Docket No. 50-316

The Commission has issued the enclosed Amendment No. 64 to Facility Operating License No. DPR-74 for the Donald C. Cook Nuclear Plant, Unit No. 2. The amendment consists of changes to the Technical Specifications and certain license conditions in response to your application transmitted by letter dated March 1, 1984, as supplemented by letters dated March 15, 23, and 28, April 19, May 4, 11, 17, 21, and 23, June 1, and 4 of 1984. This application was supplemented by letters from Exxon Nuclear Company dated March 2, 13 and 16, May 7, 21 and 22, 1984. The changes to certain license conditions is supported by letters from the licensee dated September 9, 1983 and November 11, 1983.

The amendment approves the Cycle 5 reload, changes the surveillance requirements for ice condenser inlet doors, revises the containment isolation valve list, corrects reactor coolant system indicated temperature (average) to account for instrument uncertainties, changes the requirement for rod position indication during shutdown, adjusts the flow balance for the Safety Injection System, and makes several administrative, editorial change to update Technical Specifications.

DONALD C. COOK

FIGURE 3.2-4 RCS TOTAL FLOWRATE VERSUS R - FOUR LOOPS IN OPERATION

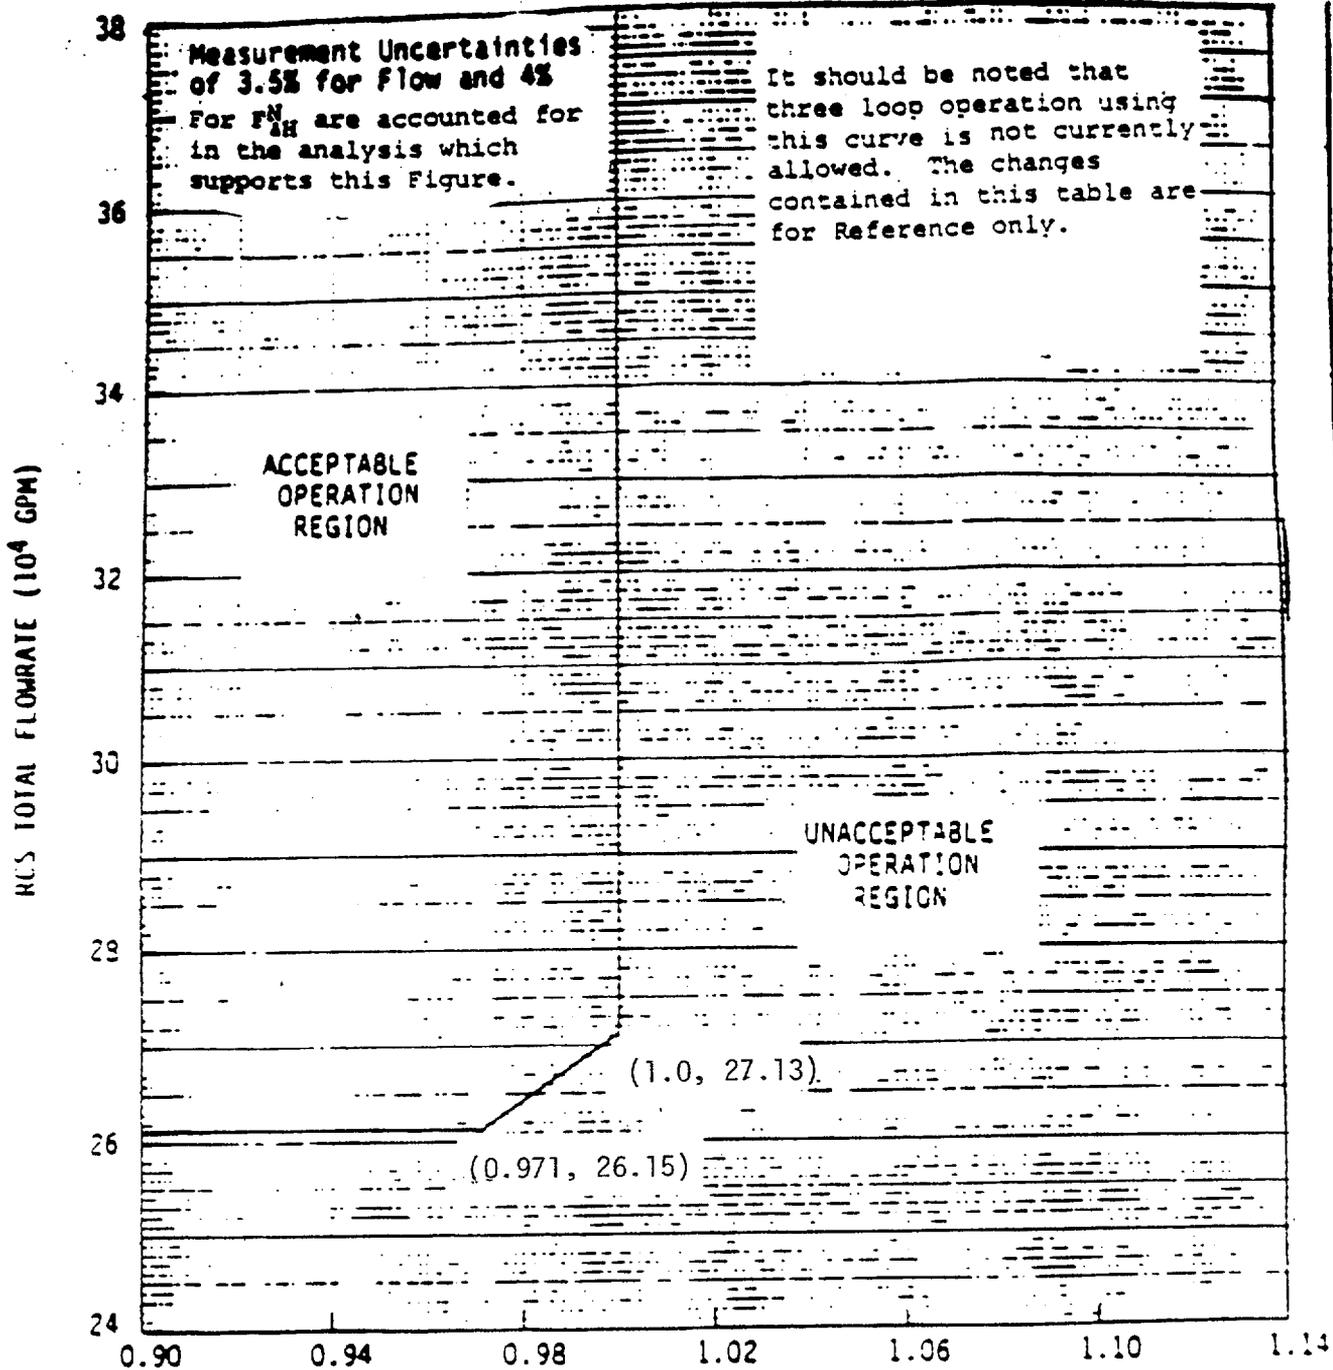
With $F_{\Delta H}^N$ above the allowable limit or with the combination of RCS total flow rate and R outside the region of acceptable operation shown on Figure 3.2-4 or 3.2-5 (as applicable):

4.2.3.2 $F_{\Delta H}^N$ shall be determined to be within the above limits and the combination of indicated RCS total flow rate and R shall be determined to be within the region of acceptable operation of Figure 3.2-4 or 3.2-5 (as applicable):

$$R = \frac{F_{\Delta H}^N}{1.48[1.0 - 0.2(1.0 - P)]} \text{ WESTINGHOUSE FUEL}$$

FIGURE B 3/4 2-2 ILLUSTRATIVE EXAMPLE OF
 $F_N / \Delta H$ LIMIT VERSUS PERCENT THERMAL POWER FOR EXXON FUEL

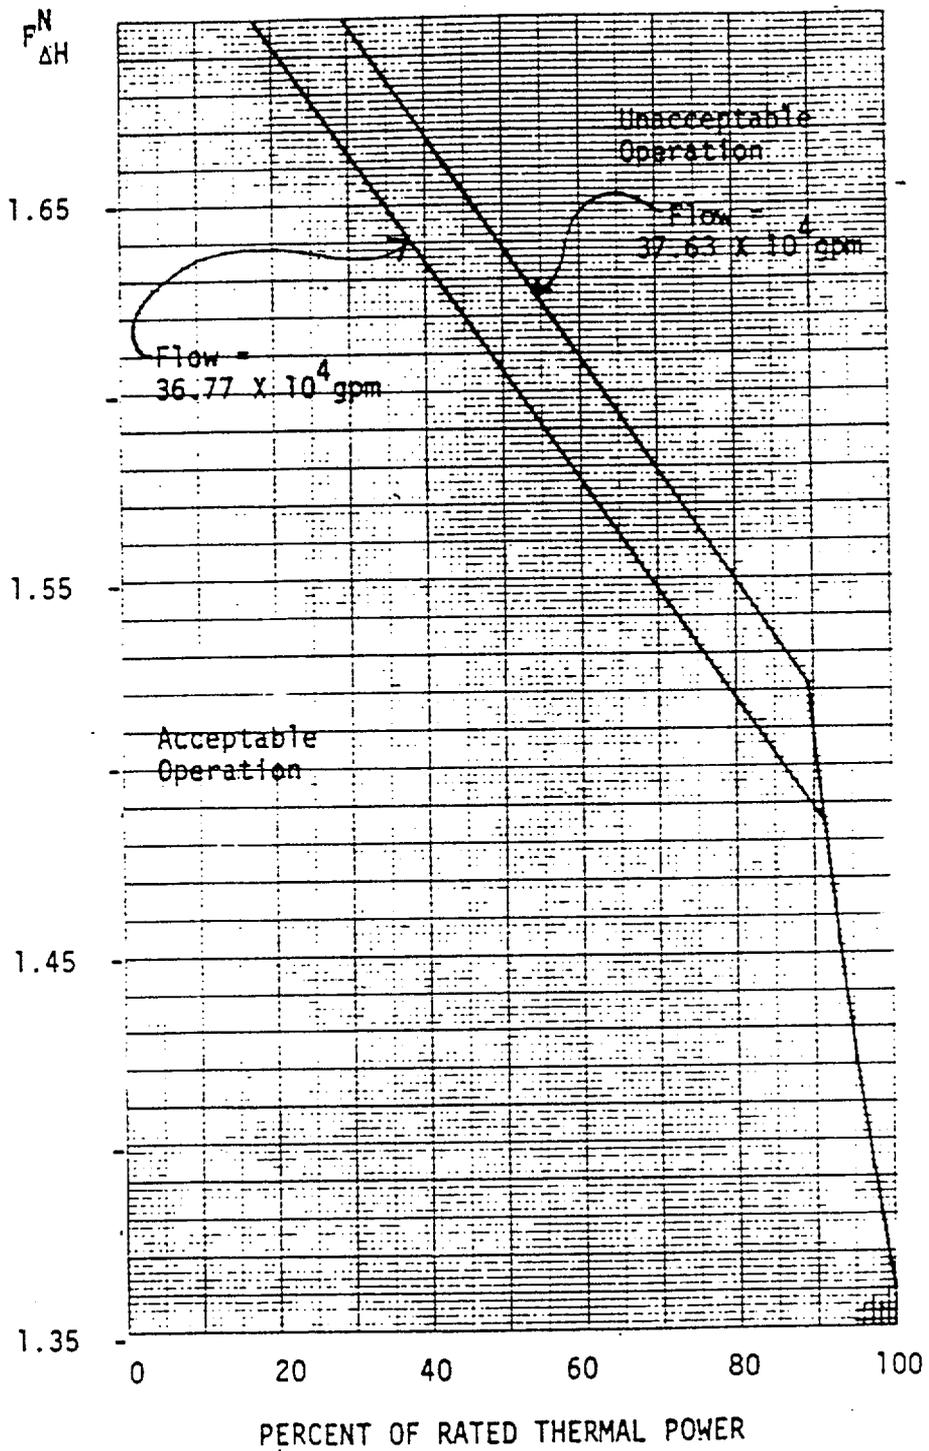
Figure B 3/4 2-2 illustrates the implementation of the limits as a function of power. A measured flow will result in a limiting value for R which must be obtained from Figure 3.2-4 or Figure 3.2-5. From this limiting R, a limiting $F_{\Delta H}^N$ can be obtained because:

Figure B 3/4 2-2 displays two limiting DNBR $F_{\Delta H}^N$ curves for Exxon Nuclear Company fuel for flows of 36.77×10^4 gpm, and 37.63×10^4 gpm. Also displayed on Figure B 3/4 2-2 is the limit on $F_{\Delta H}^N$ which results from the LOCA analysis for Exxon Nuclear Company fuel. $F_{\Delta H}^N$ must be maintained below and to the left of both the applicable DNBR $F_{\Delta H}^N$ limit and the LOCA $F_{\Delta H}^N$ limit.
